# CITY PLAN COMMISSION STAFF REPORT

27<sup>th</sup> & Troost – Cardinal Crest Apartments

CD-CPC-2025-00042  
Development Plan

Case Number: CD-CPC-2025-00042

L1

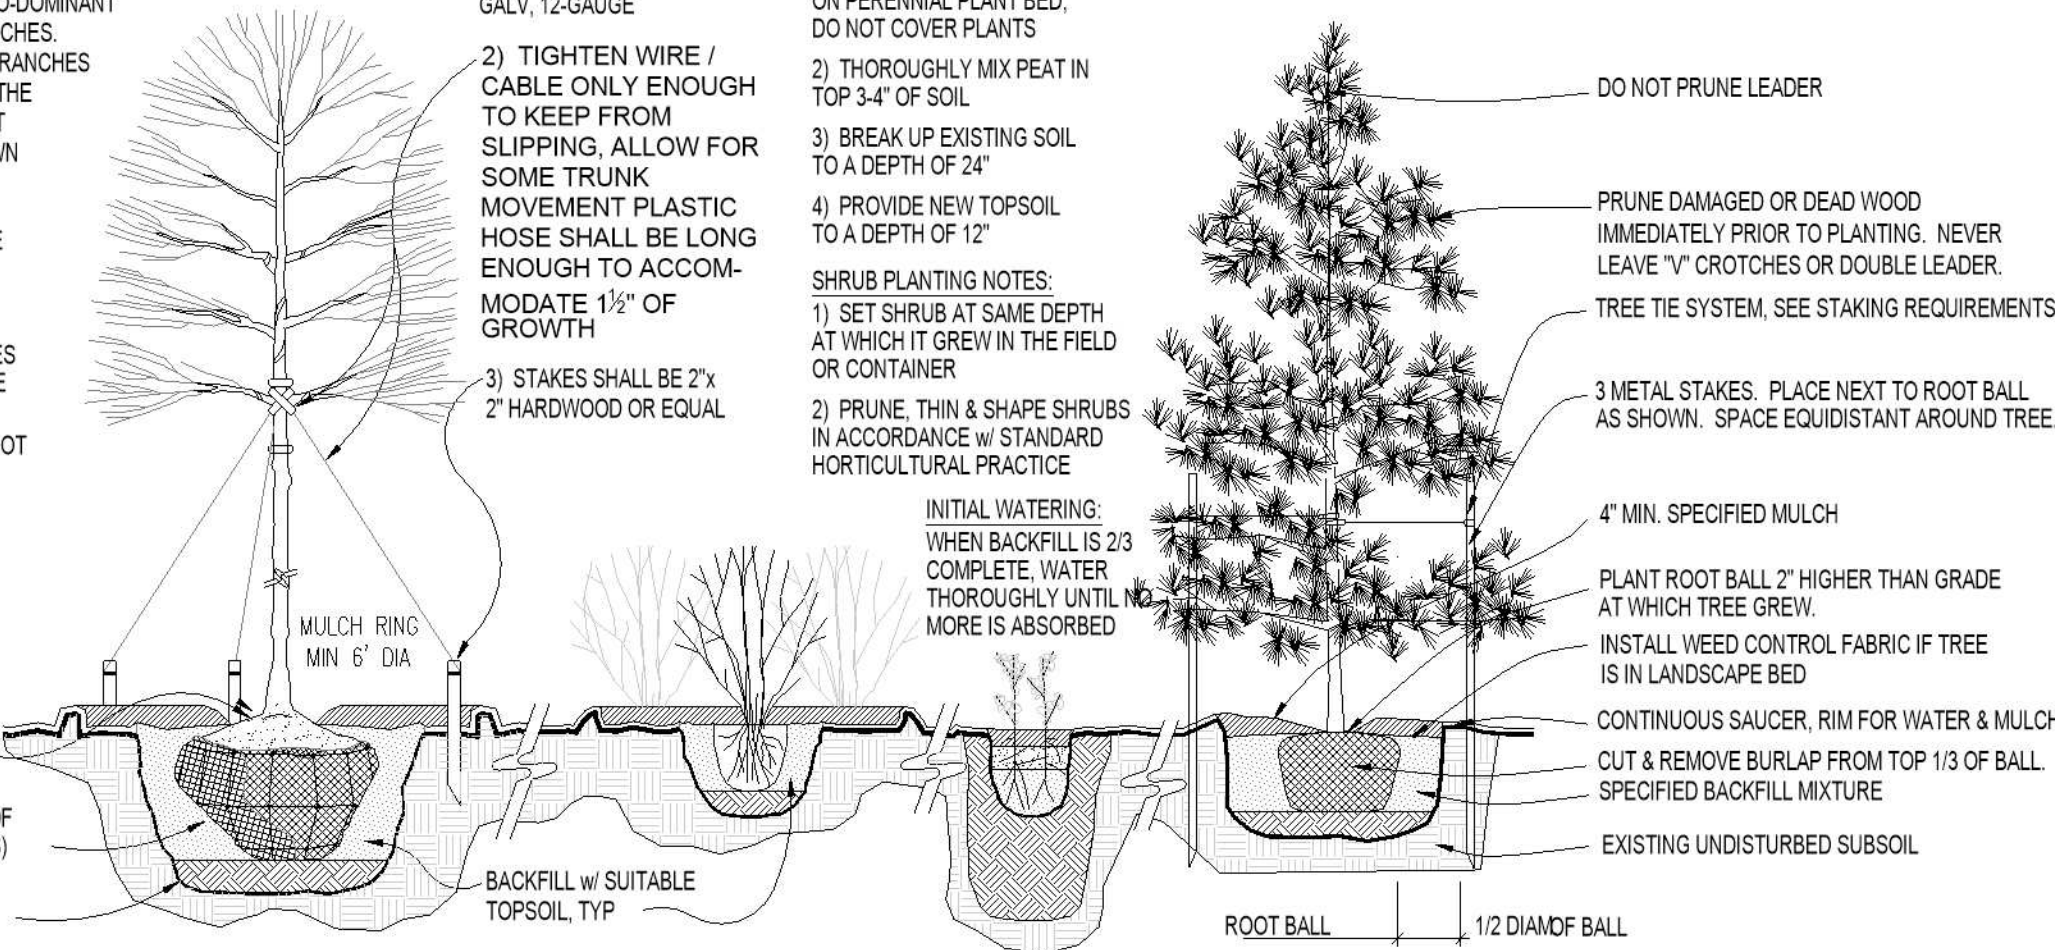
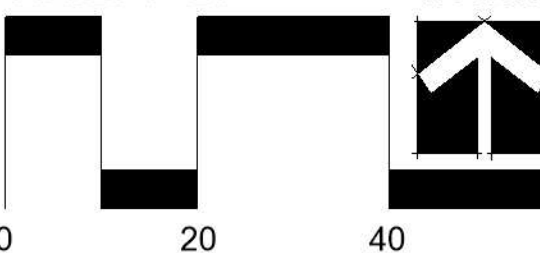
(1) update the Capitol Sales Tax Fund - Tree Planting Table to take into account the trees and shrubs not being planted on the site and the trees being removed on the property. Per the City Forester Memo, each tree = \$185 per caliper inch, and shrub/bush = \$40 each.

EXTERIOR BUILDING ELEVATIONS  
SITE 1

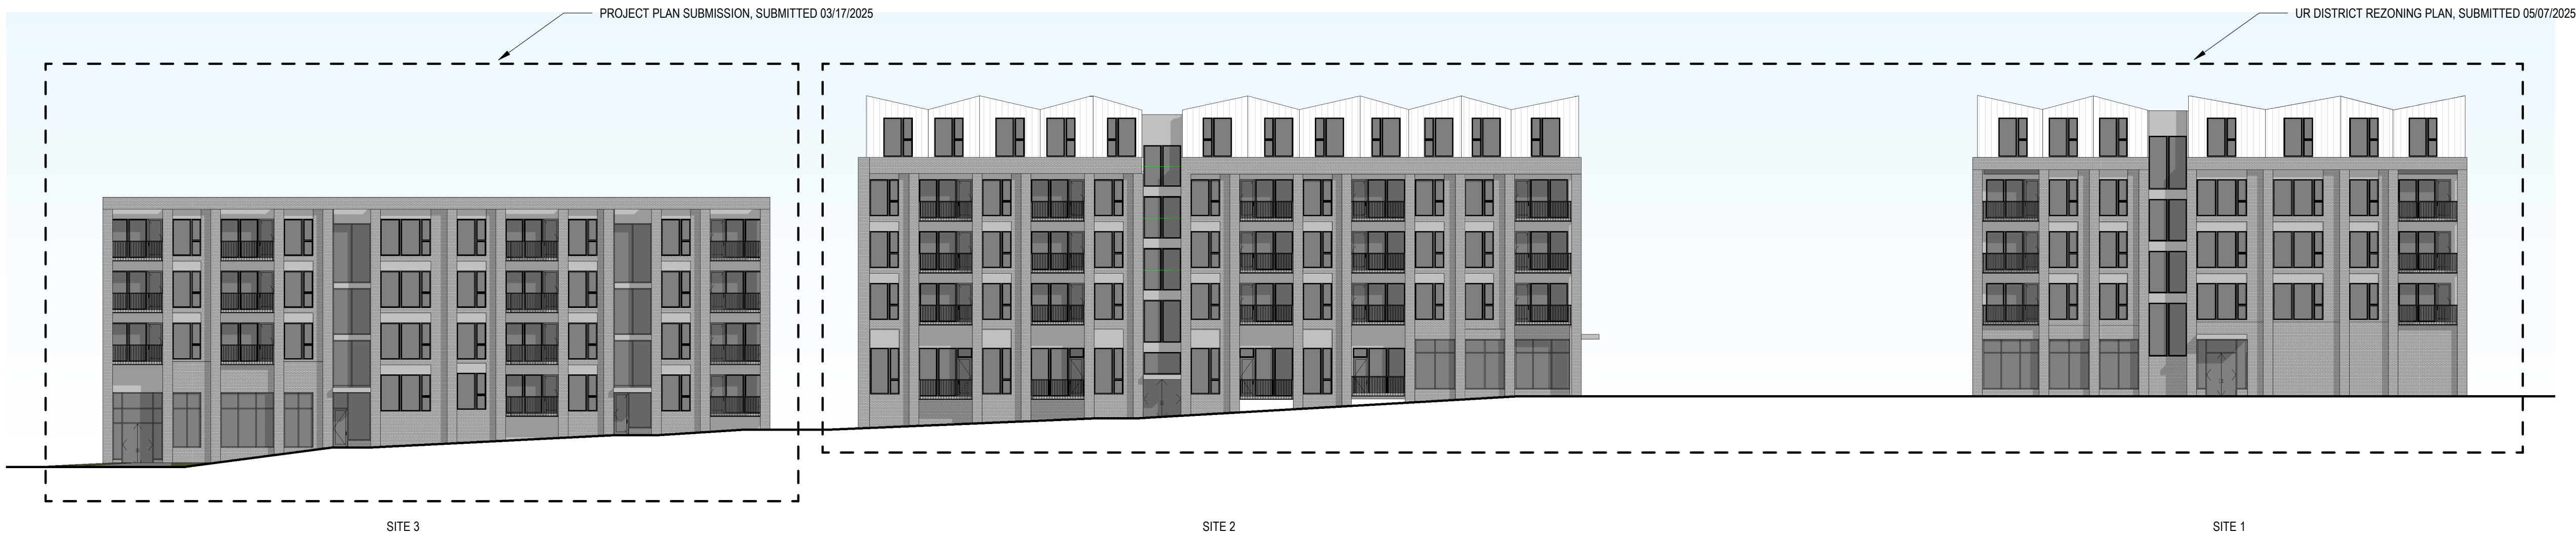
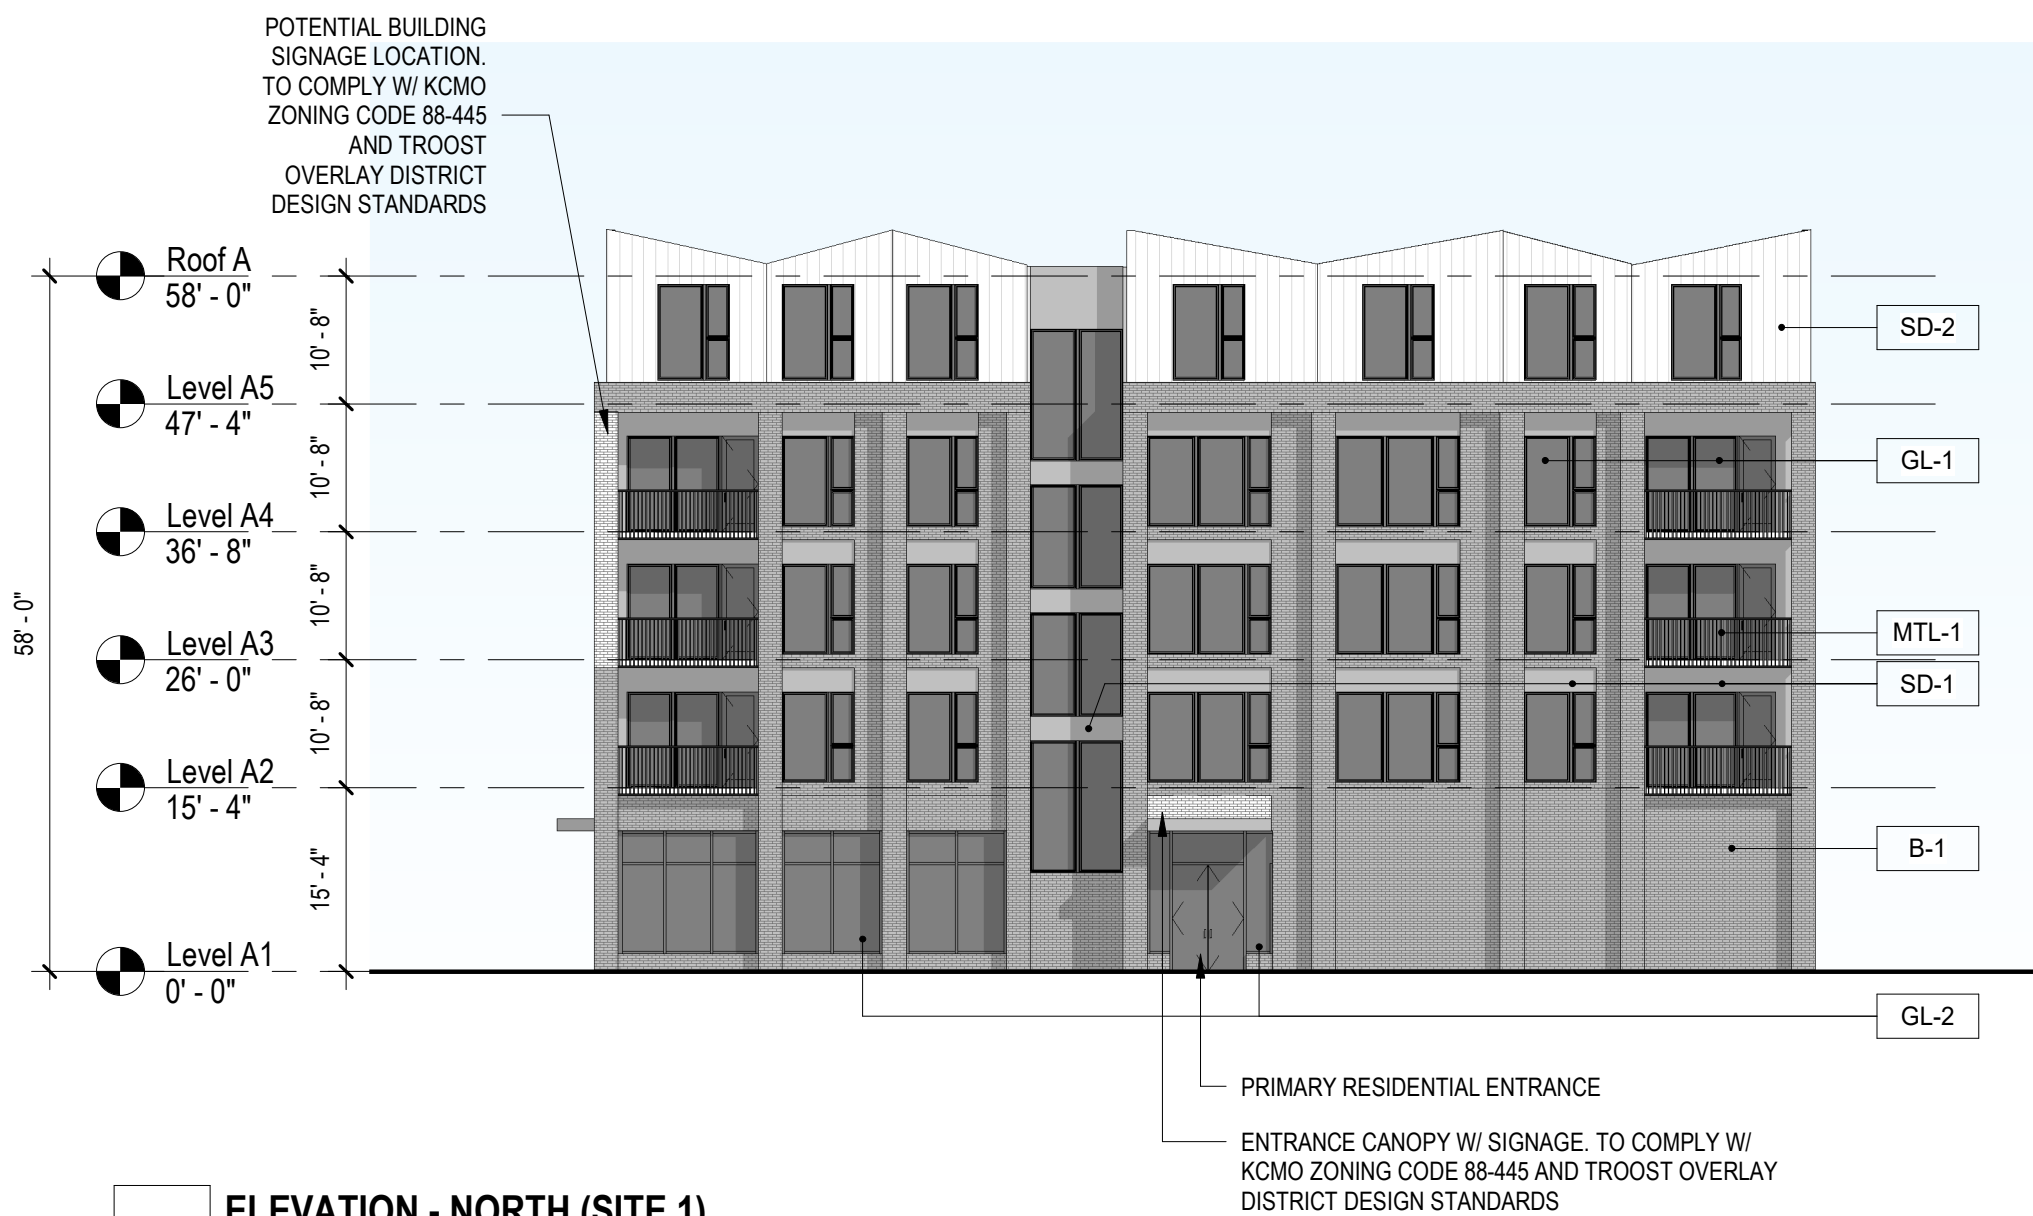
6. A deviation to the maximum height of a mixed-use building within the Beacon Hill UR Plan to permit a 58-foot-tall building.
7. The developer shall secure approval of a UR final plan from Development Management Division staff prior to building permit. The following corrections/amendments shall be addressed in the UR final plan,
